Subject: Las Vaqueros Reservoir 275,000 acre-feet - CCWD Board to flounder in Closed Session

**INSPECTION OF DAM AND RESERVOIR IN CERTIFIED STATUS**

Name of Dam Los Vaqueros Dam No. 1019-003 County Contra Costa  
Type of Dam Earth fill Type of Spillway Concrete ogee and chute  
Water is 7 feet below spillway crest and 21 feet below dam crest.

Photo 2 – View of downstream slope taken from V-channel on right side of dam showing slope vegetation and animal burrows.

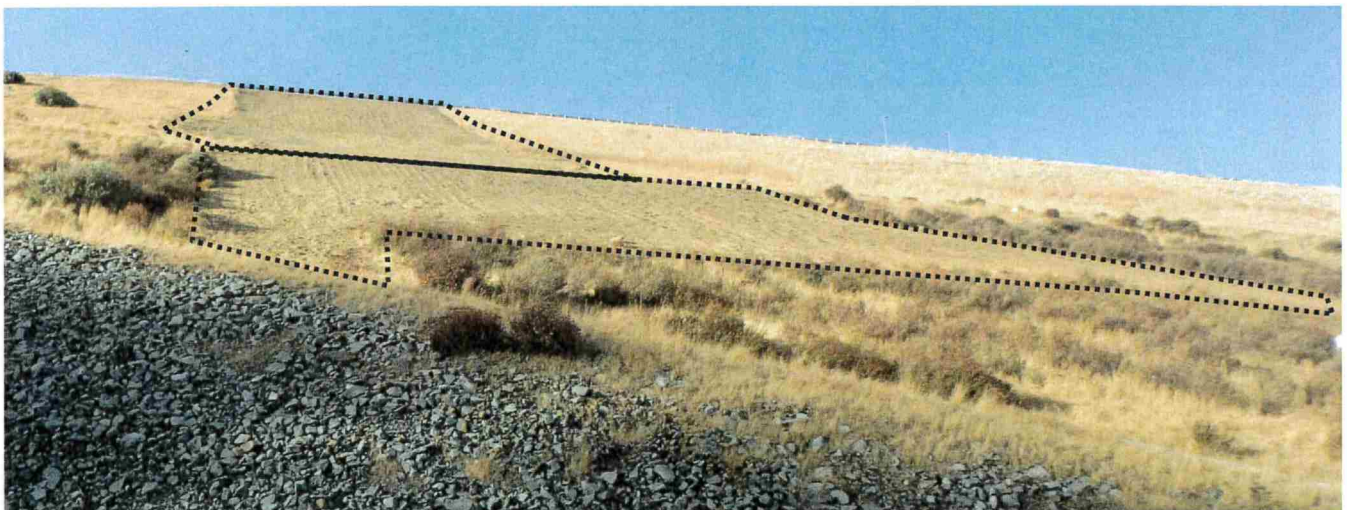
Woody vegetation on the downstream slope needs to be removed. The dense grass on the downstream face prevents adequate assessment of the magnitude of animal burrows and localized depressions. The grass needs to be mowed periodically, and the owner needs to inspect the downstream face for animal burrows and localized depressions.

The visible portion of the riprap-covered upstream slope of the dam appeared to be satisfactory with mild sparse vegetation and debris, and no signs of slope instability (Photo 1). Upstream vegetation should be monitored to ensure no perennial growth occurs. The downstream slope of the dam contained numerous visible animal burrows, and areas of mild to moderate vegetation obstructing inspection (Photo 2). Woody vegetation on the downstream slope needs to be removed. The dense grass on the downstream face prevents adequate assessment of the magnitude of animal burrows and possible localized depressions. The two surficial slumps previously reported were repaired, and hydroseed was recently placed (Photo 3). The rock fill against the lower right abutment appeared to be satisfactory.

Photo 4 – Close-up of longitudinal crack on left side of dam along asphalt crest.

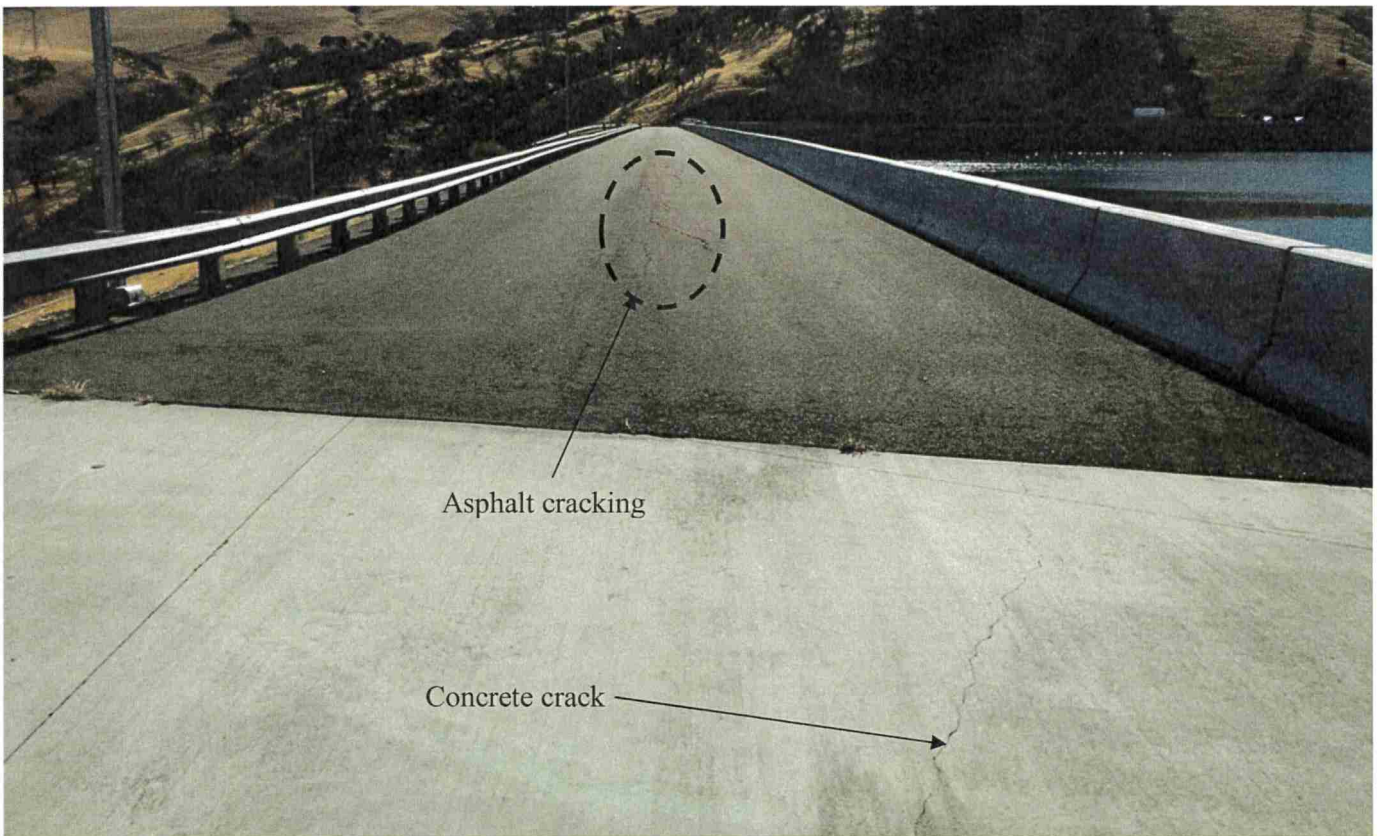
Longitudinal cracking was observed along the paved asphalt and concrete covered portion of the crest right of the spillway bridge. The asphalt cracking (approximately 120-foot-long) was previously patched in some locations, but is now open up to 1/2-inch-wide toward the center of the cracking, and is propagating longitudinally (Photo 4). The concrete crack (approximately 15-foot-long) was surficial (<1/8-inch-wide), but only 20-feet away from the asphalt crack (Photo 5). This cracking needs to be patched and closely monitored visually. The upstream slope on the left side of the dam (upstream of the longitudinal cracking) should be visually monitored for signs of movement or bulging. The downstream slope on the left side of the dam (downstream of the longitudinal cracking) should be cleared of vegetation obstructing visual assessment and should be closely monitored for signs of movement or bulging.

Photo 6 – Separation in parapet wall where asphalt and concrete meet on dam crest.

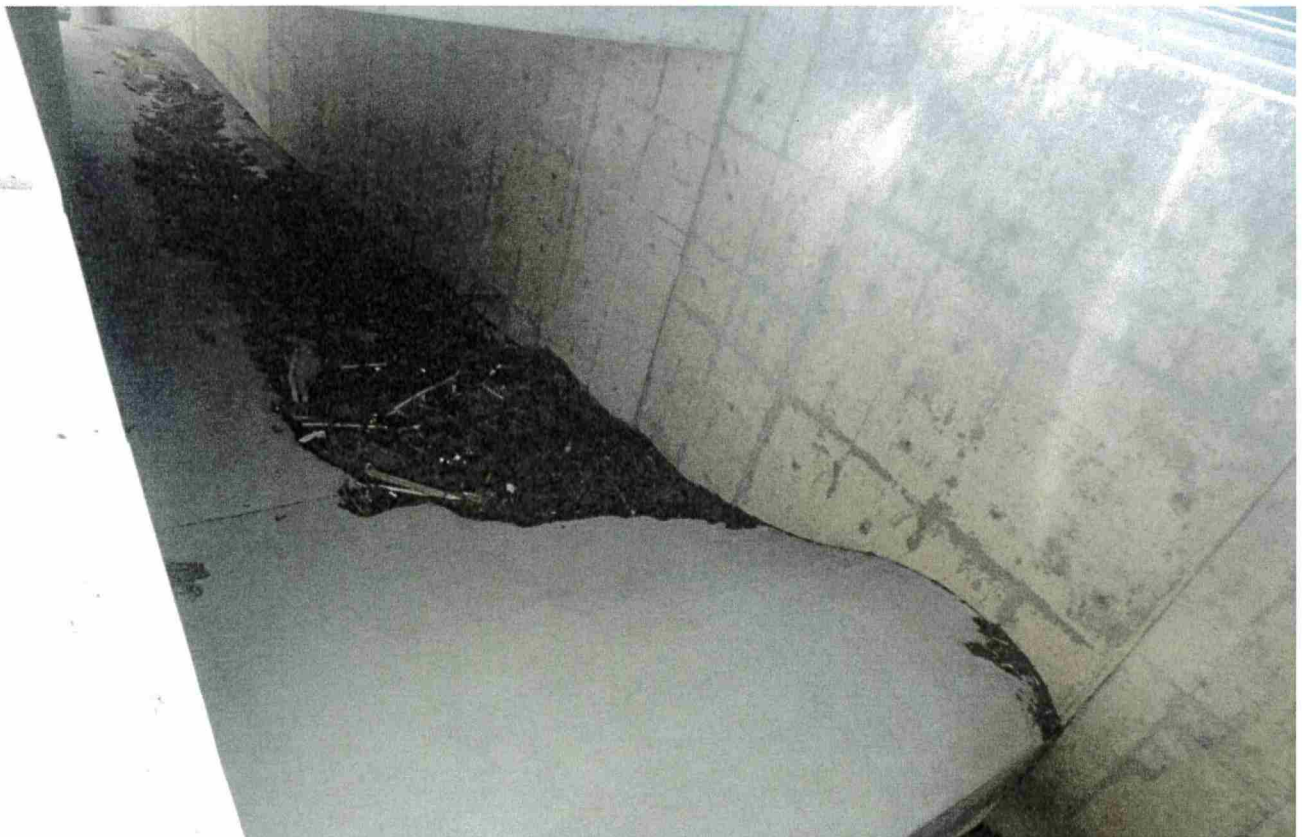
There was also a mild separation on the parapet wall where the asphalt and concrete sections meet (Photo 6). This parapet wall should also be monitored for movement. There was no visible evidence of slope movement either upstream or downstream of the crest.
